MEMORANDUM

SUBJECT: The Grove staff review

The Grove at Shoal Creek

Figure 2.3: Development District Map

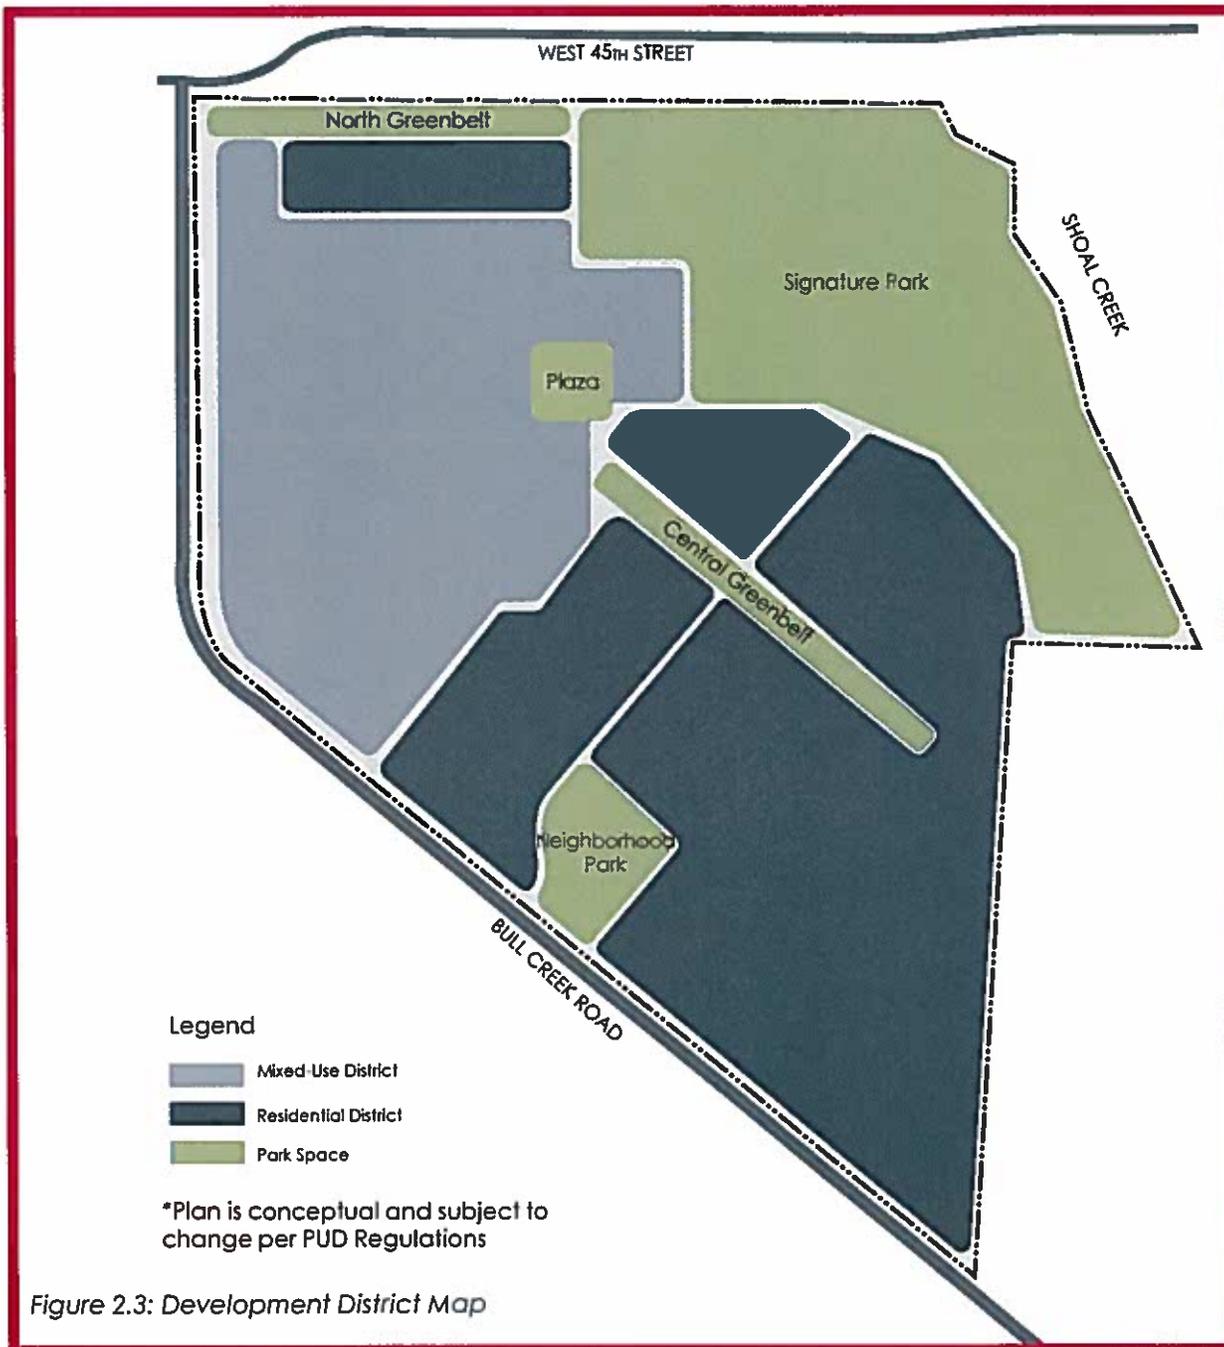
1. The Development District Map (Figure 2.3 on page 7) was updated to reflect the new Jackson Avenue alignment. *(Clarification)*
2. Section 2.4.3 has been updated to reflect the correct park spaces and to allow "Park buildings and park structures" as permitted uses within the parks and open space. *(Clarification)*

Figure 2.5: PUD Land Use Plan

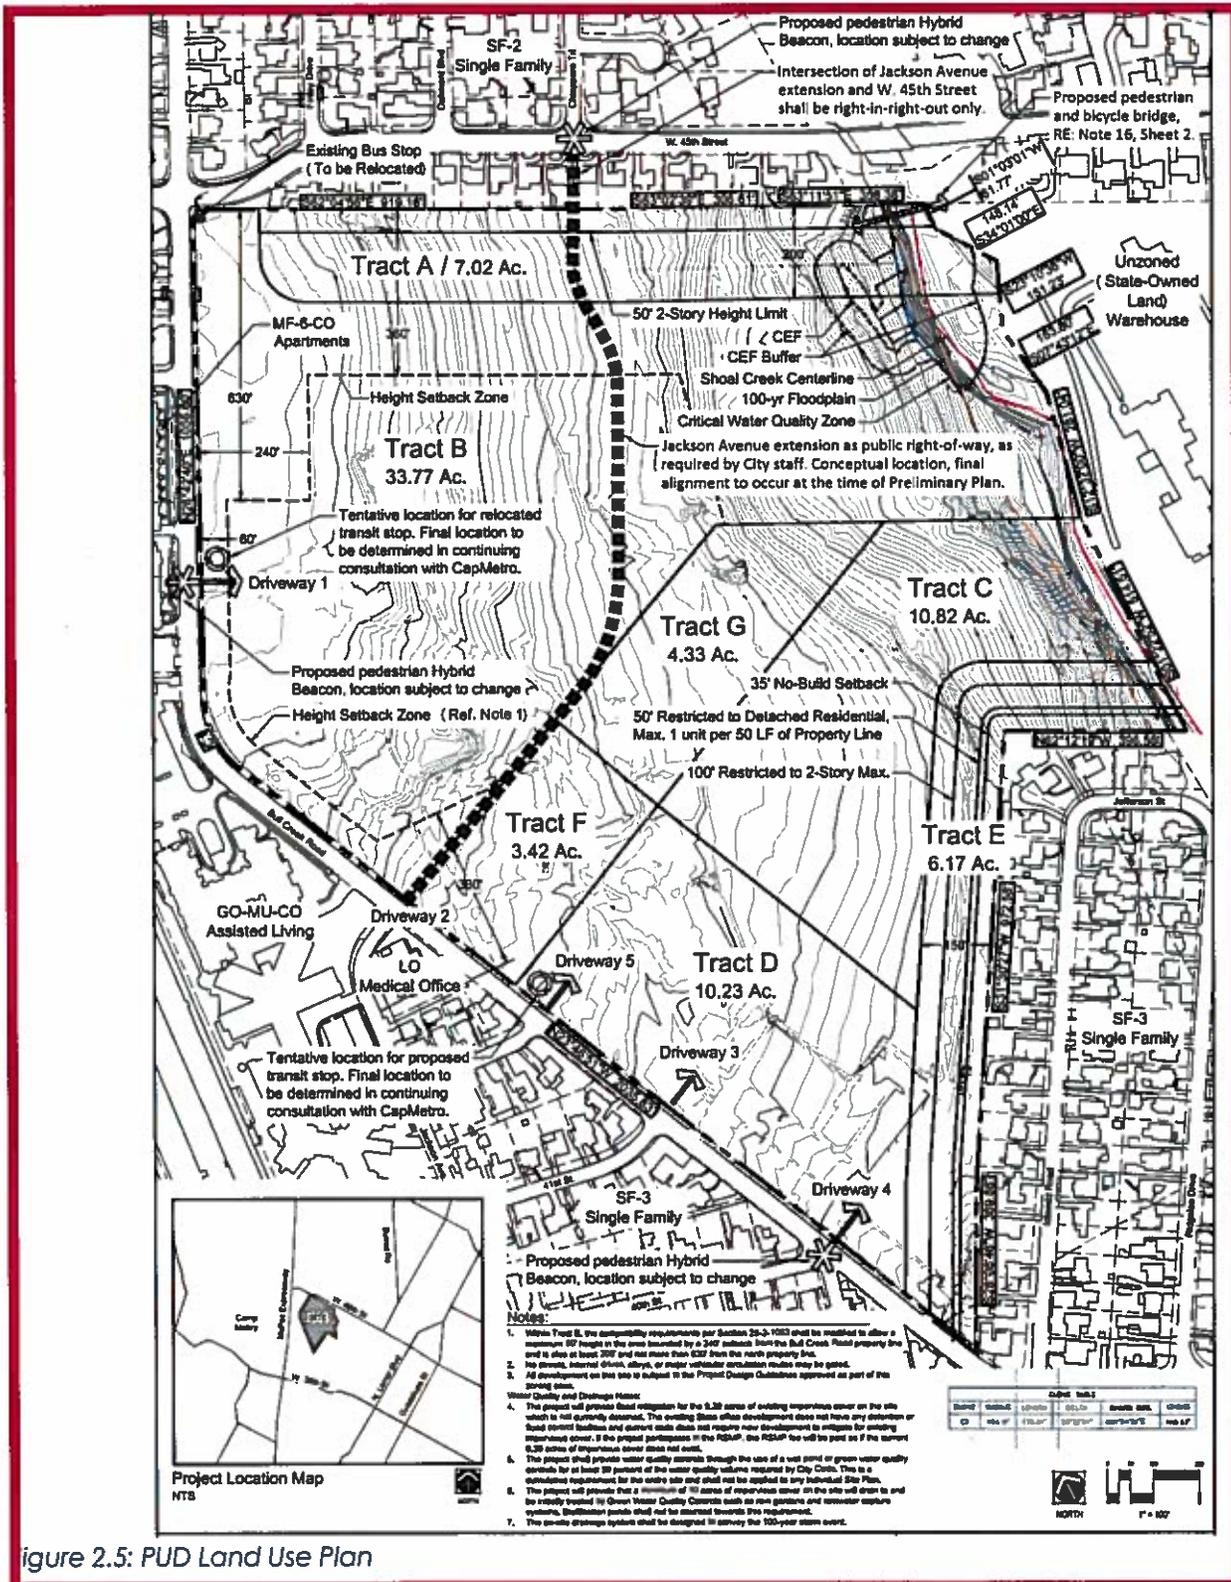
3. The PUD Land Use Plan (Figures 2.5 and 2.5.1 on pages 9 and 10) has been updated with the new sheets. *(Clarification)*
4. The Master Framework Plan (Figure 3.3 on page 13) has been updated to reflect the new Jackson Avenue alignment. *(Clarification)*

Figure 3.4.1: Bull Creek Road

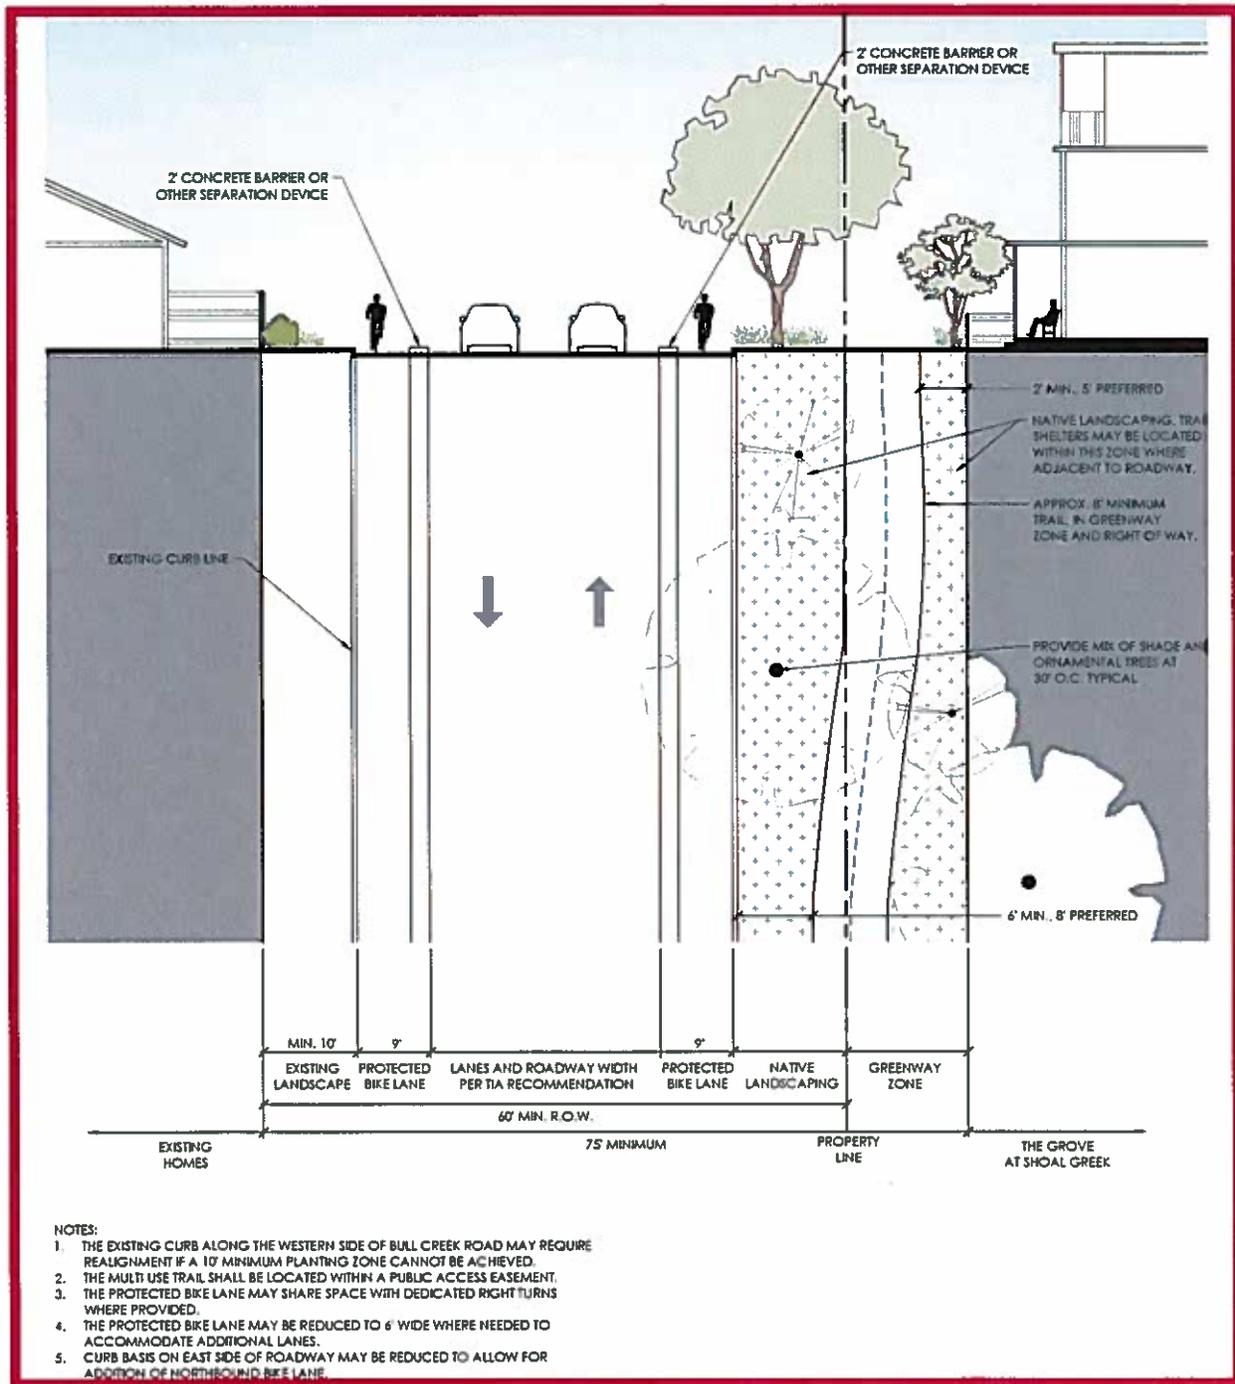
5. The Bull Creek Road section (Figure 3.4.1 on page 14) has been updated to include a northbound bike lane. *(ZAP Recommendation)*
6. The Retail Main Street section (Figure 3.4.2a on page 15) has been updated to allow for alternative parking configurations. *(Per meeting with City Staff on 8/9/16)*

Figure 3.4.2.b: Retail Main Street - Parkway Alternative

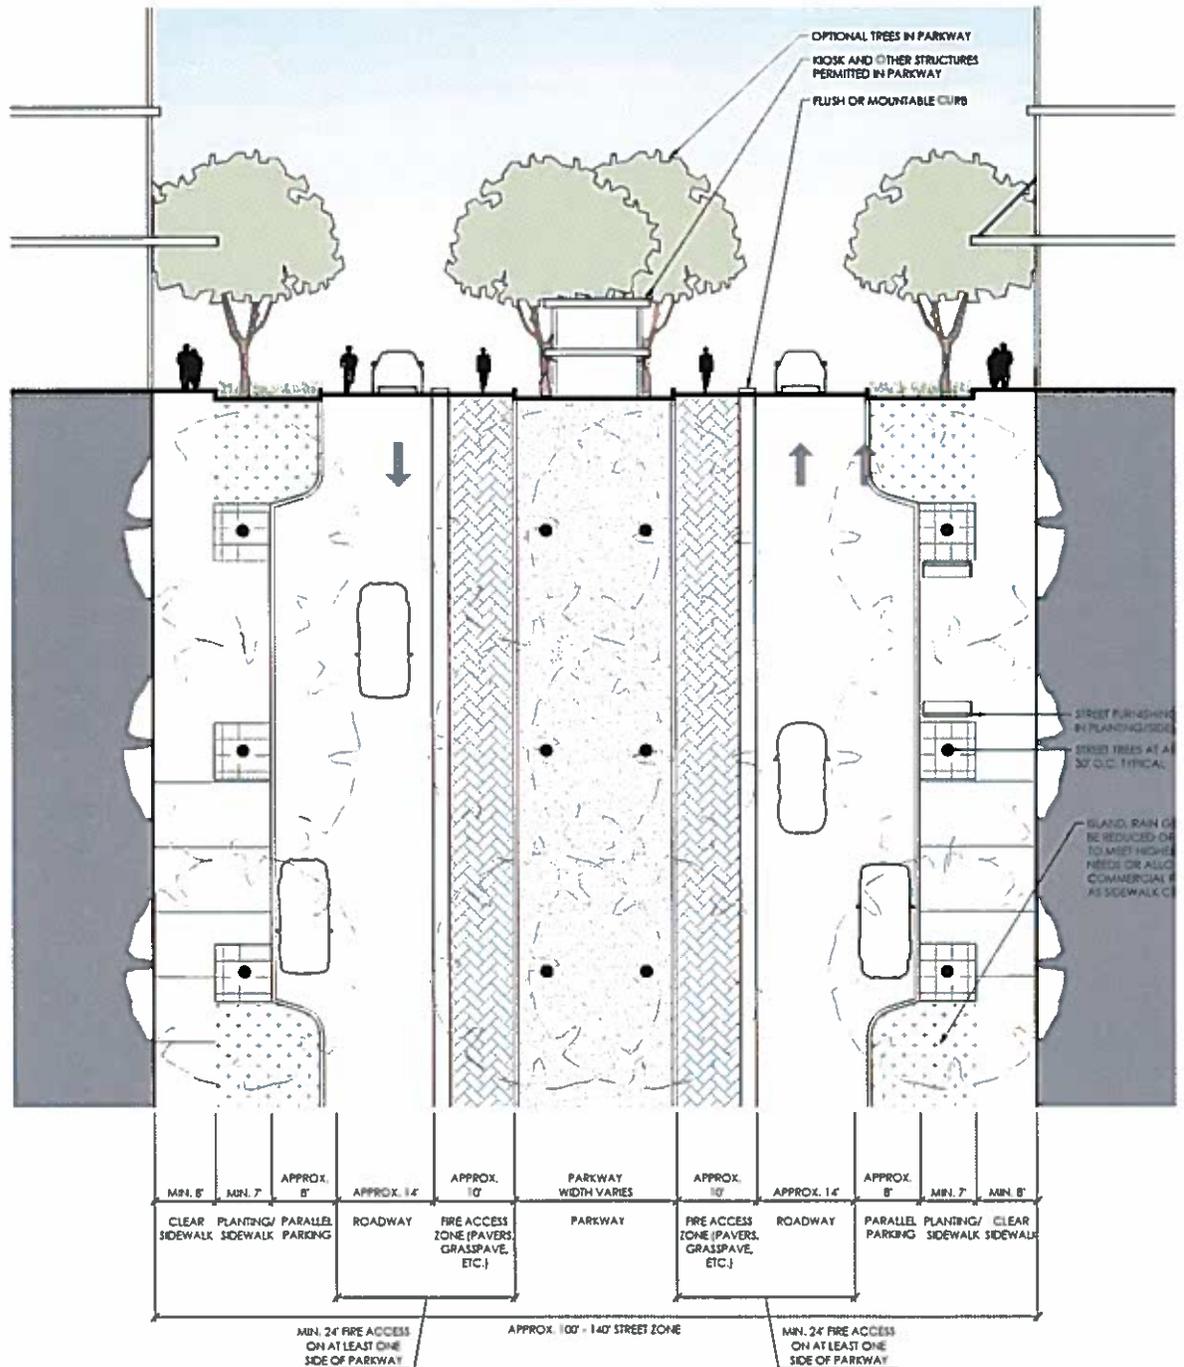
7. An alternative Retail Main Street section (Figure 3.4.2b on page 16) has been added to allow for a potential parkway configuration. *(Per meeting with City Staff on 8/9/16)*

Figure 3.5.8: Slip Road

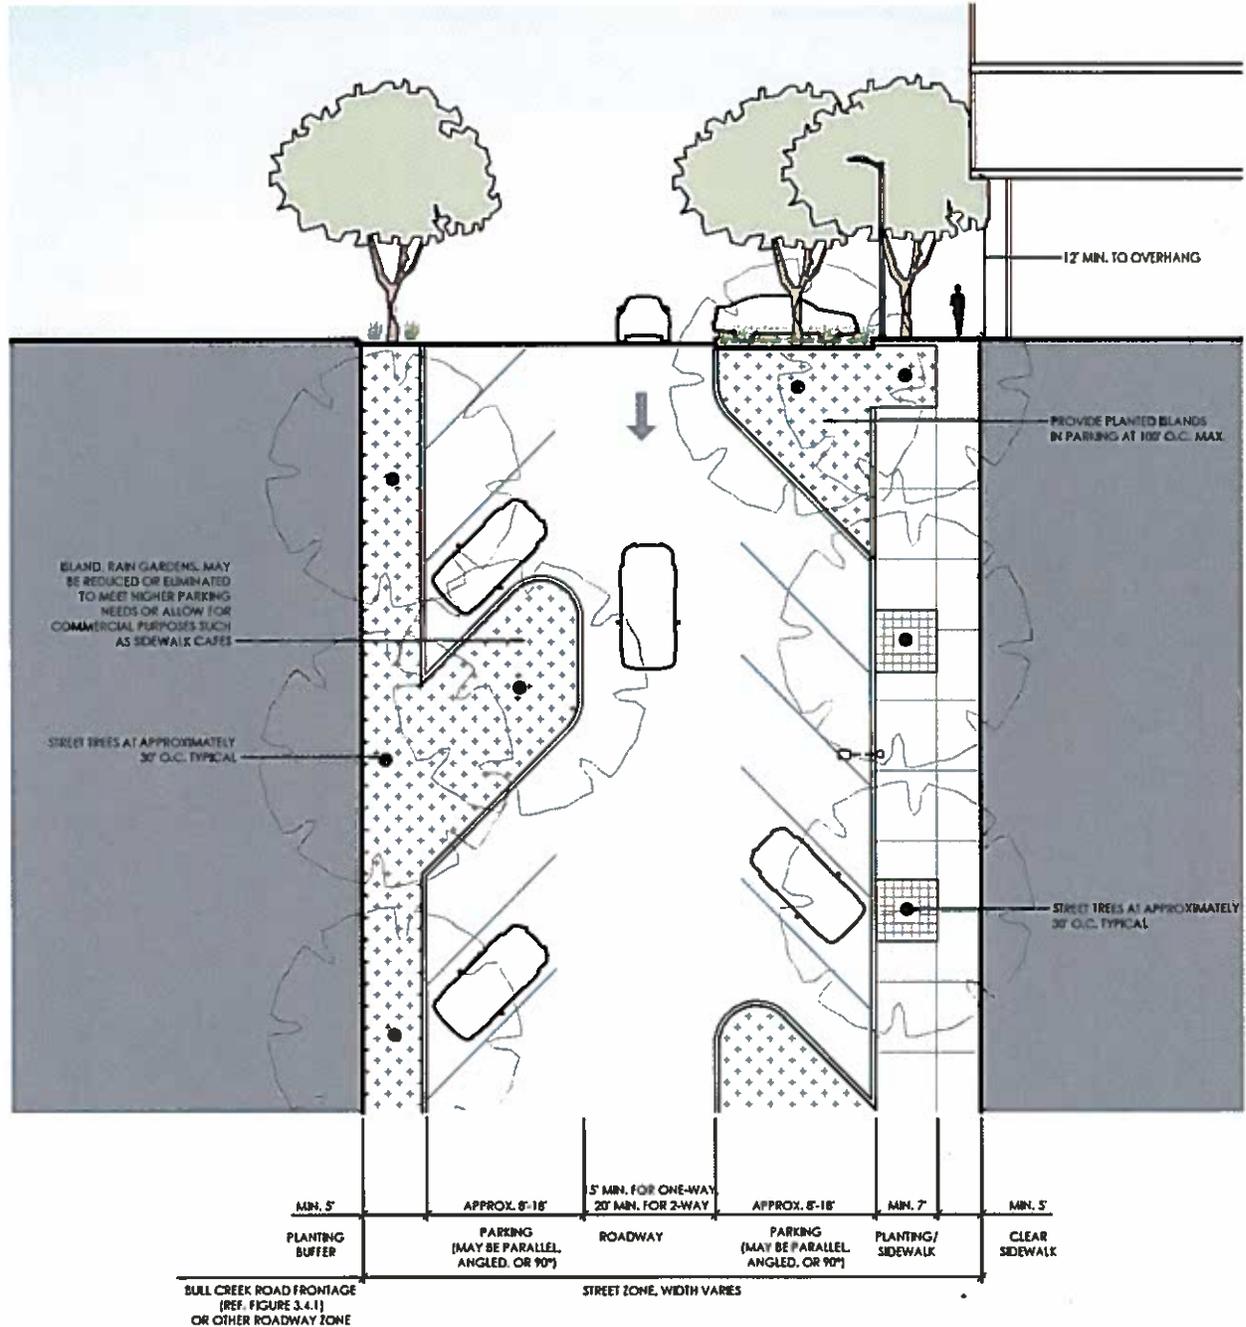
8. An additional street section (Figure 3.5.8 on page 25) has been added to allow for a slip road. *(Per meeting with City Staff on 8/9/16)*
9. Section 3.6.2 regarding Typical Traffic Circles has been updated to clarify language and note that this is an optional facility. *(Clarification)*

Figure 4.4.3: Residential Development on Parks

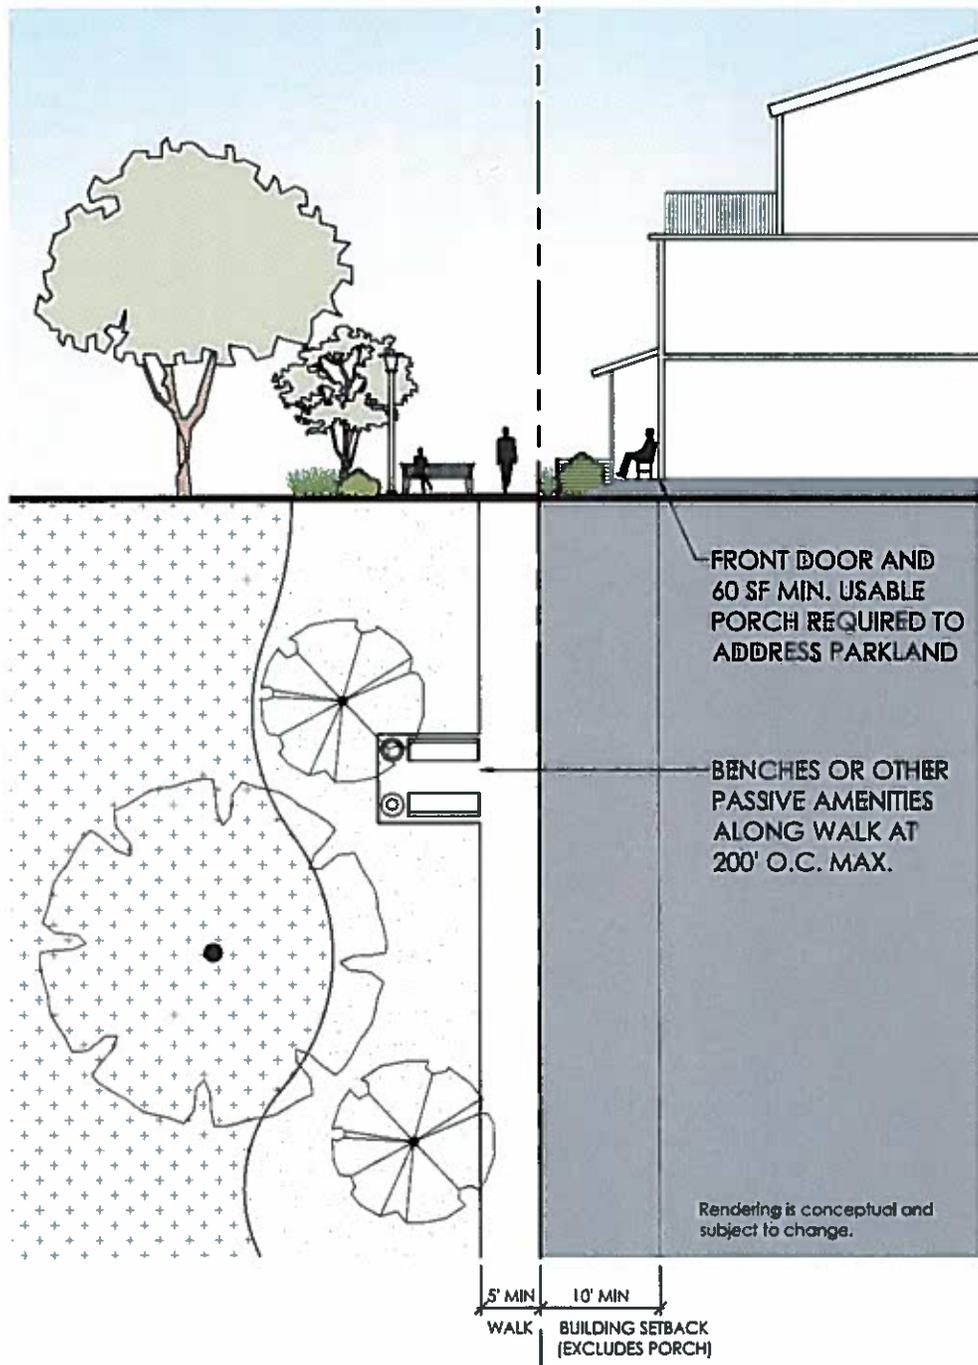
14. Section 4.4.2(e)(5) has been added to clarify that glazing requirements do not apply to parking structures. *(Clarification)*
15. Section 4.4.3(c) and Figure 4.4.3 have been added to govern residential development adjacent to parks. *(Condition of PARD Superiority)*
